Product Change Notification

113407 - 00

Change Notification #: 113407 - 00
Change Title: Intel® Server System R1304GL4DS9
PCN 113407-00
Product Design, Label
Update the System Rear Panel, Quick
Reference Label and Add a Mylar and a
Plastic Block
Date of Publication: November 19, 2014

Figure One

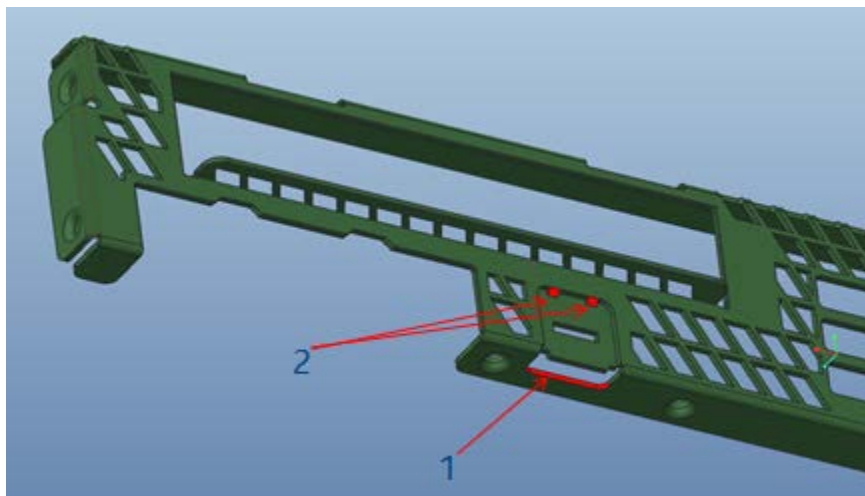
1. Add a connection at the bottom of the RMM4 (Remote Management Module 4) slot to improve structure strength. See item 1 in the Figure One.
2. Update the one big center joint to two smaller joints so that the joints will not conflict with the LAN cable connector latch. See item 2 in the Figure One.

Figure Three

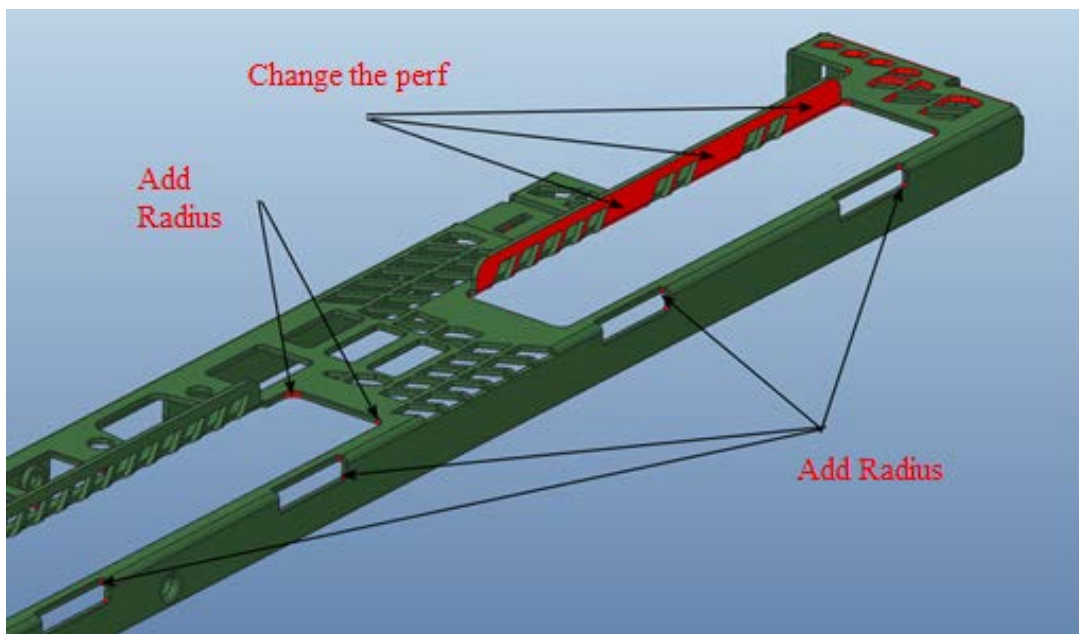
4. Update the perf and add radius to improve structure strength. See the Figure Three and Four.

Figure Five

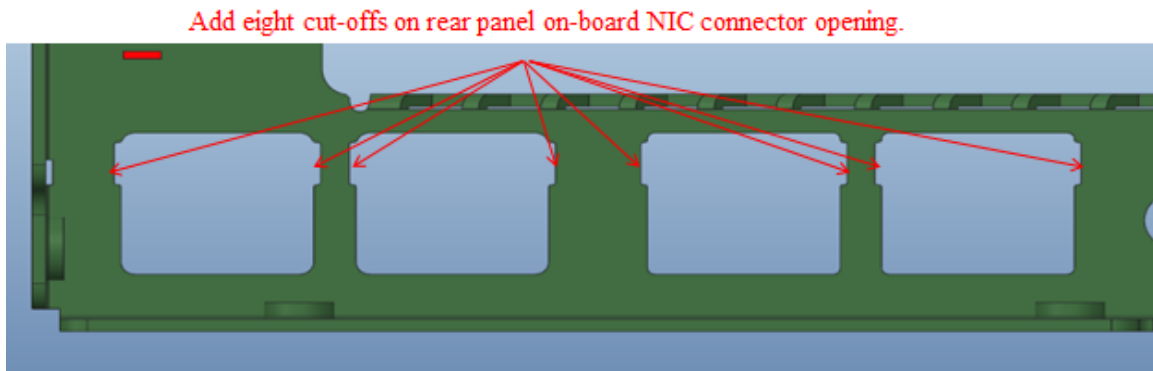
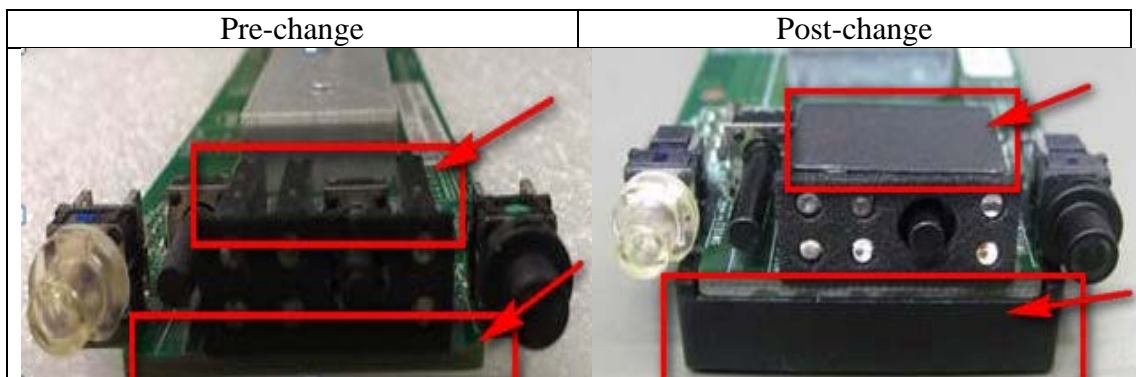
5. Add eight cut-offs around the on-board NIC (Network Interface Controller) openings to improve the LED visibility. See the Figure Five.

Figure Six

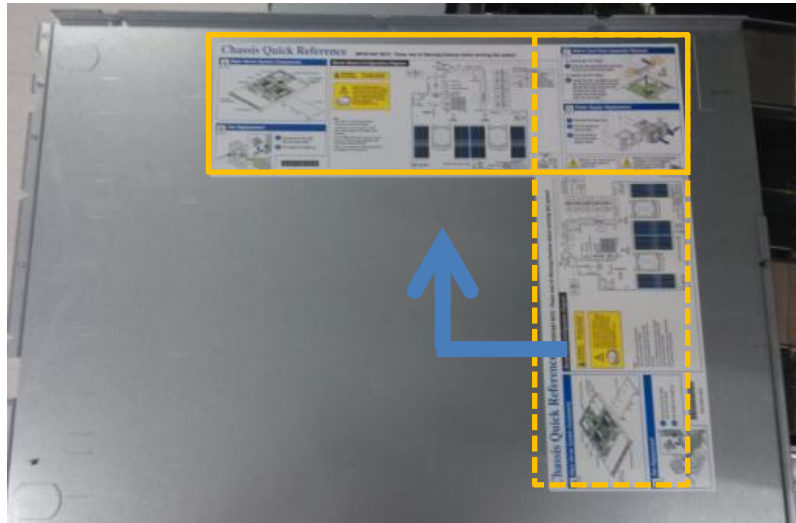
- Rotate the orientation of the Quick Reference Label by 90 degree. The new location of the label is above the power supply unit cage and the air duct. See the Figure Six.
